Ref: 0417r02v02

**RE: 227 BUNGARRIBEE ROAD, BLACKTOWN (DA-21-00559)
KRISHATHI PTY LIMITED -V- BLACKTOWN CITY COUNCIL (LEC CASE NO. 2021 / 146822)
LETTER OF RESPONSE TO TRAFFIC CONTENTIONS**

We refer to recent correspondence concerning the abovementioned Court proceedings and the Statement of Facts and Contentions (SOFC) issued by Blacktown City Council (Council) dated 14/07/2021, relating to the deemed refusal of Development Application, DA-21-00559.

BUNGARRIBEE ROAD

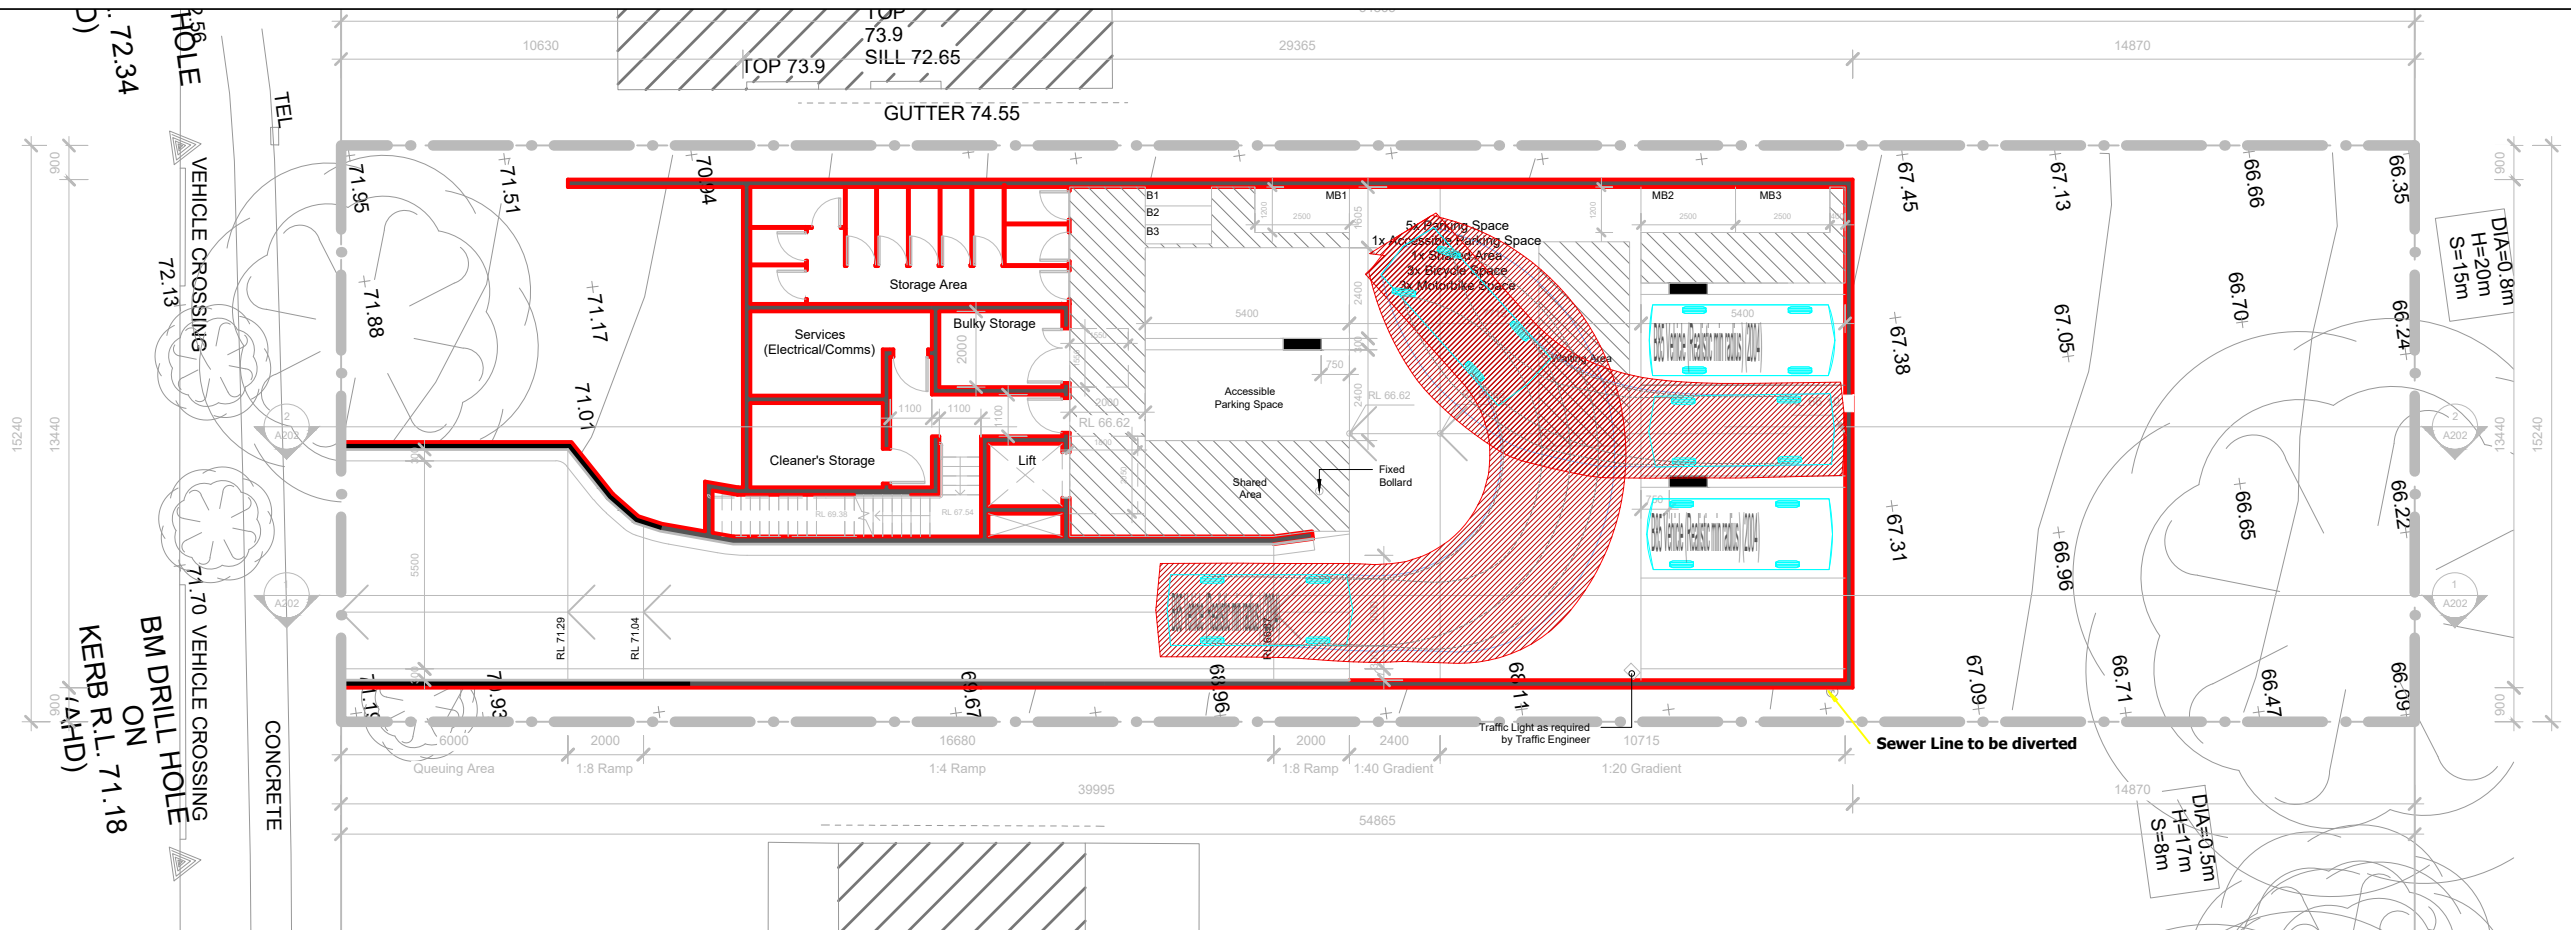
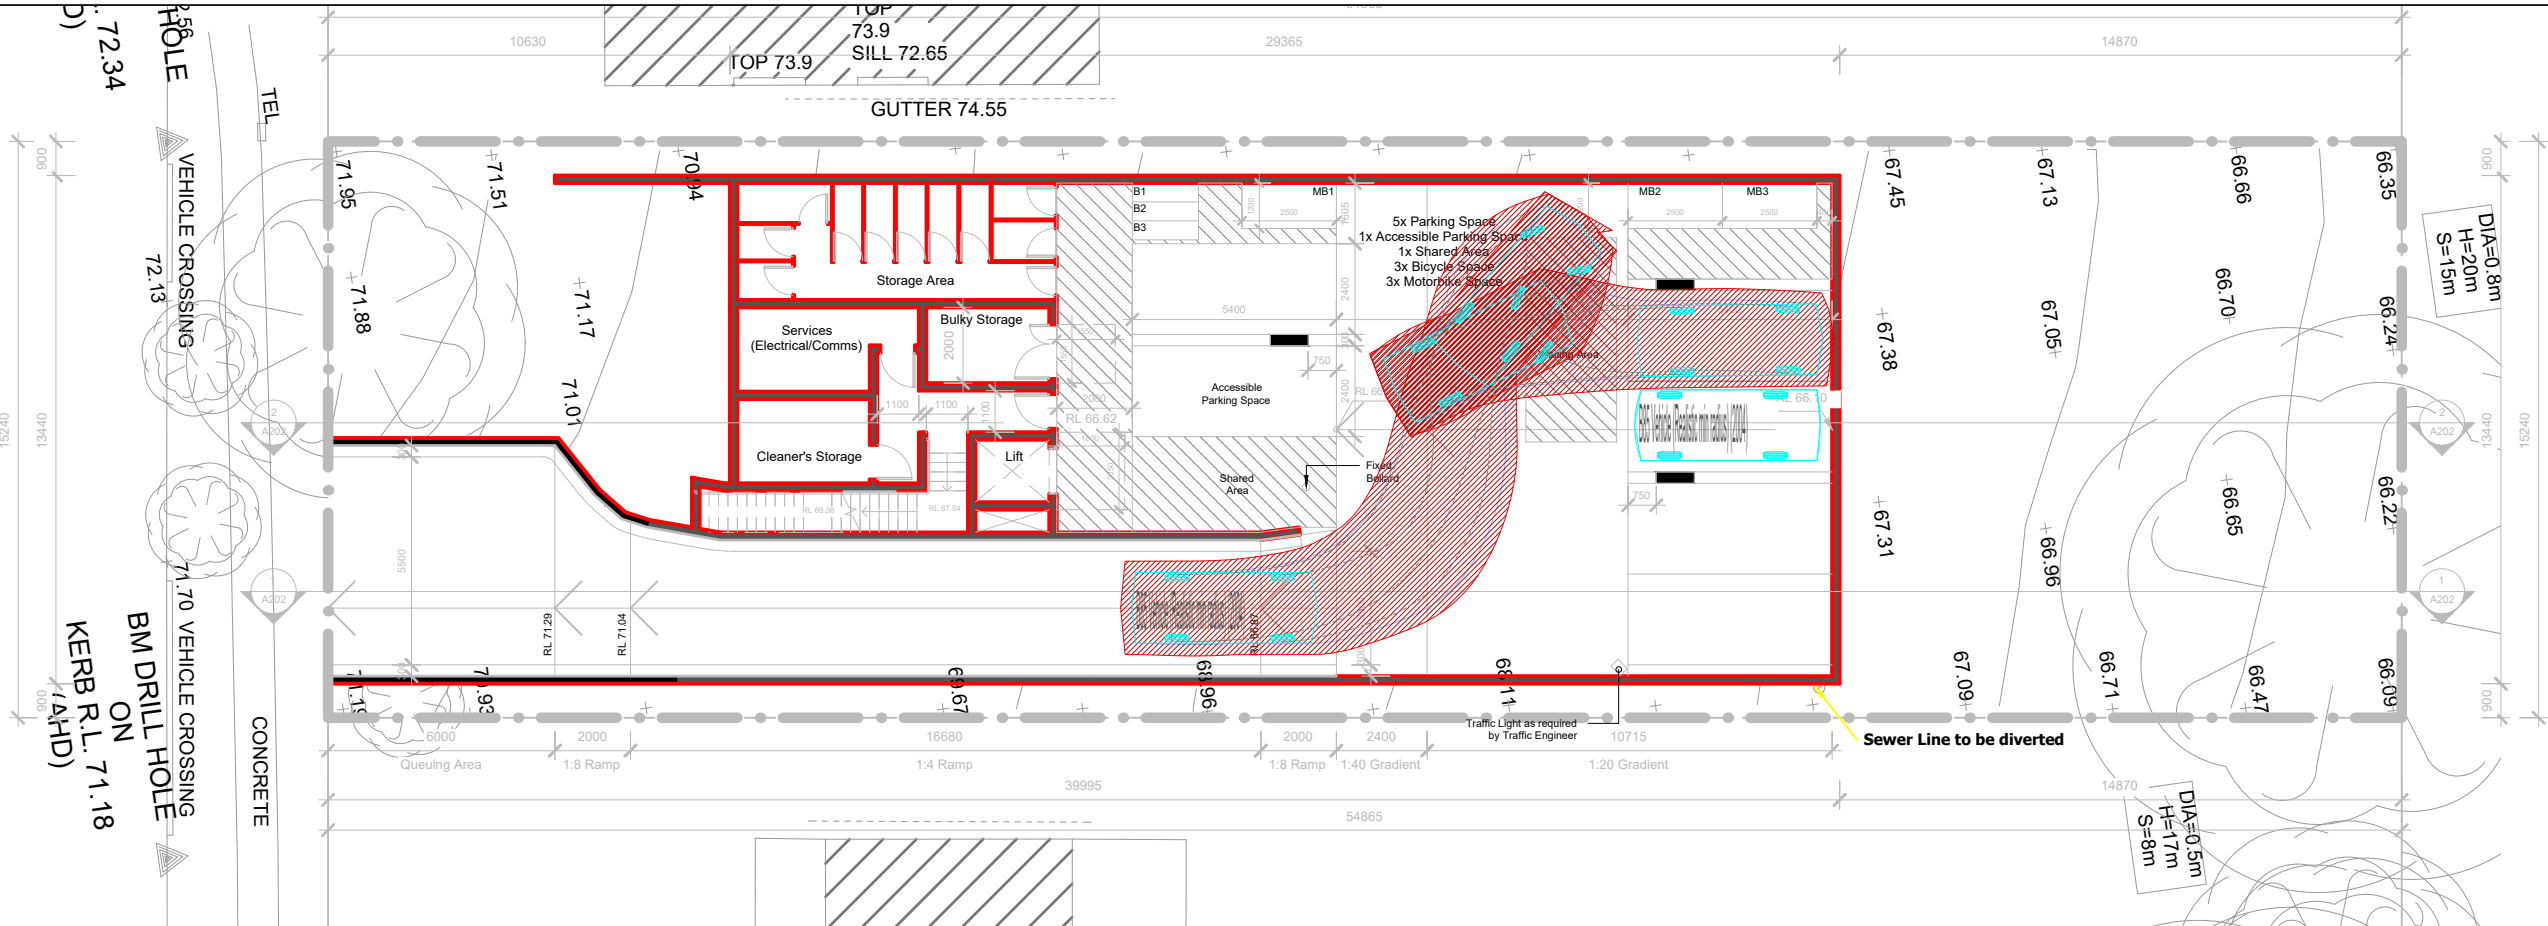
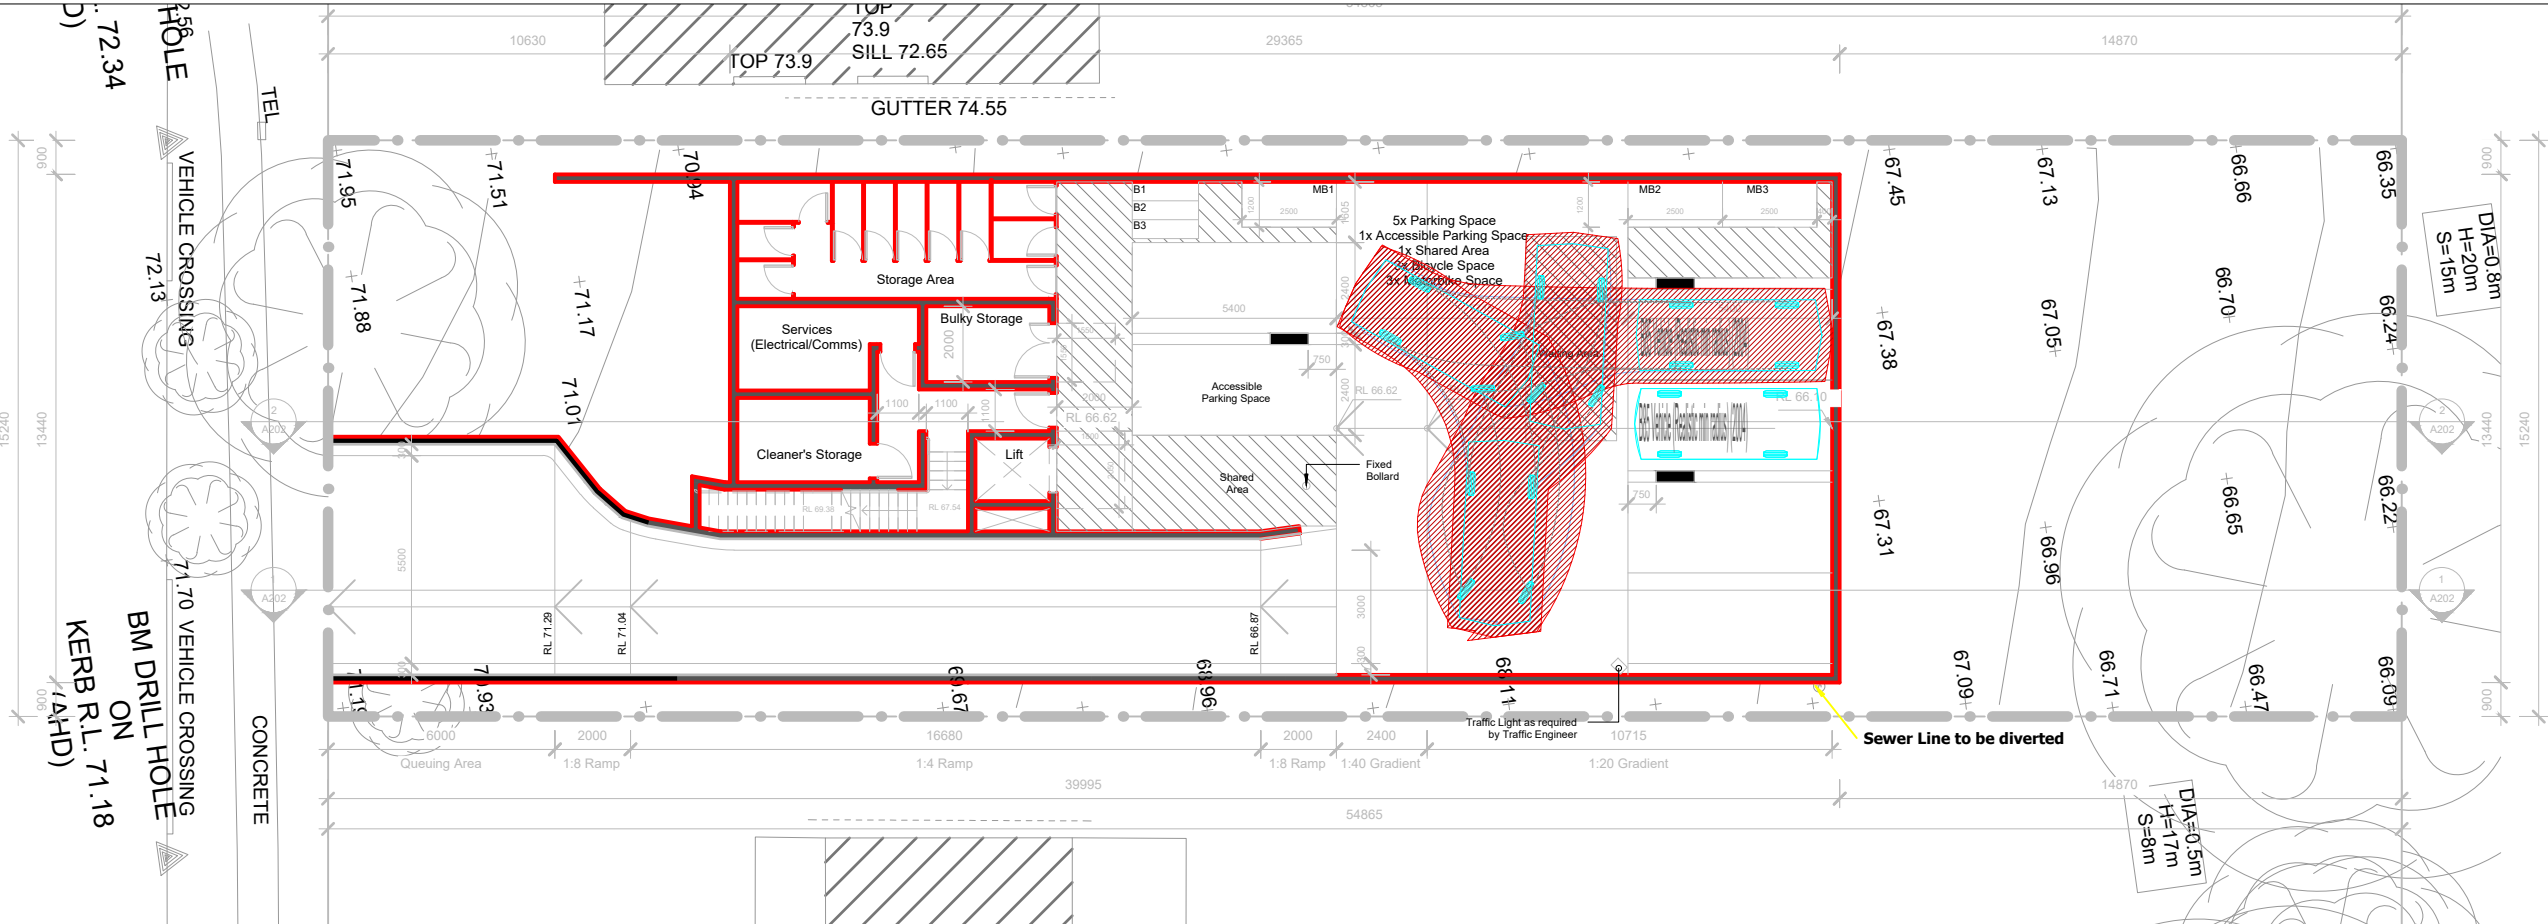
b) Insufficient turning circles have been provided in accordance with Section 2.5.2 of AS2890.1 for passing at the site driveway and within the basement. Turning paths are to be provided for the B99 design vehicle turning left into the site driveway from the public road and passing a B85 design vehicle exiting the site in addition to swept paths for the B99 design vehicle within areas designed for use by one vehicle at a time.

d) Turning circles in the basement are not practical or workable for cars. The results show the required 0.3m vehicle clearance overlapping with high obstructions (walls, columns, motorcycle spaces, kerbs and car parking spaces) which is contrary to the requirements of AS2890.1. It appears 'turn on spot' has been used for swept paths (basement and along the driveway) which is a design flaw not representing realistic vehicle manoeuvres. The dwg files for the swept paths are to be provided.

Updated swept path analysis has been undertaken of the vehicle access with the results provided as **Attachment 2**. The results demonstrate satisfactory turn movements for a:

- B99 Design Vehicle turning left-in and left-out of the access driveway from the public road and passing a B85 Design Vehicle.
- B99 Design Vehicle entering the basement car park and passing a B85 Design Vehicle situated within the waiting bay.
- B99 Design Vehicle exiting the basement car park.
- B85 Design Vehicle entering / exiting all car spaces.

The results demonstrate satisfactory operation of the car park and compliance with Appendix B of AS 2890.1.

As per our respond to Contention 6(b), updated swept path analysis has been undertaken of the basement, including for entry / exit to all car spaces with the results provided in **Attachment 2**.

The 'turn from stop' function has only been used where a vehicle has changed from a forward-movement to a reverse-movement or from a reverse-movement to a forward-movement as is standard practice in the traffic engineering profession. The updated swept path results also show that 0.3m clearances are now clear of all vehicle obstructions including walls, columns, motorcycle spaces, kerbs and car parking spaces.
